Proposal for Supplement 8 to the 02 series of amendments to Regulation No. 51 (Noise of M and categories of vehicles)

I. Proposal

"Figure 2

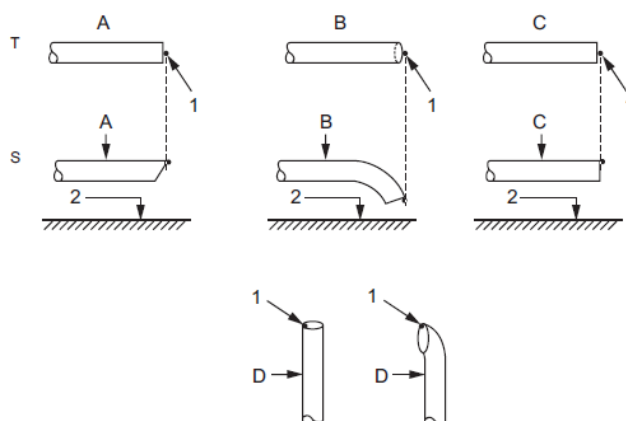
Annex 3, Appendix, Figure 2, amend to read:

This proposal aim to update the above figure to be in line with the latest amendment of ISO 5130:2012 and in line with the 04 draft series of amendment of Regulation No.41, ECE/TRANS/WP.29/GRB/2011/3.
